THOMAS COMITTA ASSOCIATES, INC.
Town Planners & Landscape Architects

MEMORANDUM

SUBJECT: **REVIEW COMMENTS: 446 STONY RUN (BECHTEL FARM AT STONY RUN) -
PRELIMINARY/CONDITIONAL USE SUBDIVISION AND LAND DEVELOPMENT PLAN,
DATED REVISED 9-8-2023; AND SUPPLEMENTAL MATERIALS**

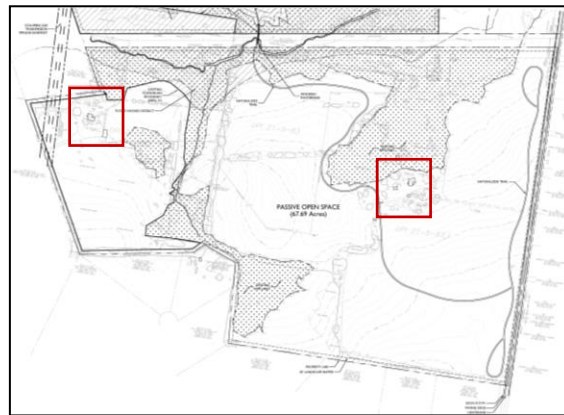
In addition, the previous plan set that included the parcel located off of Bridge Street, illustrated additional buildings on the property (see below). The Site Analysis and Impact Assessment Narrative and EIS should also **still** be expanded to include these buildings/dwellings.

AUGUSTA LED LUMINAIRE WITH DUNMORE FITTER

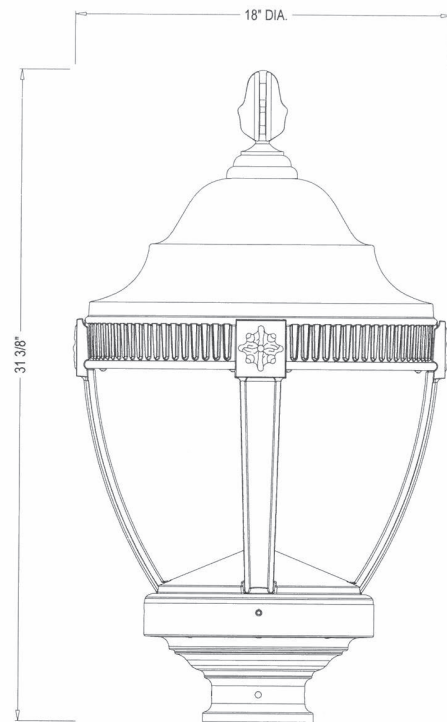
- 9.12. We **still** defer to the Township Solicitor relative to the content of the draft HOA Declaration. **Also see comment 4.2.**
- 9.16. The Street Light Lamp Fixture is proposed to be Augusta Round Roof with Dunmore Fitter. Instead of the 37" height, we **still** recommend a height of 31 3/8" consistent with the attached cut sheet. (See attached cut sheet.)

- 9.18. The mounting height should **still** be revised to reflect the pole heights of 12'-6" and 13'-6" poles, plus the 31 3/8" light fixture. The mounting height should be the overall height, measured from the ground to the top of the light fixture.
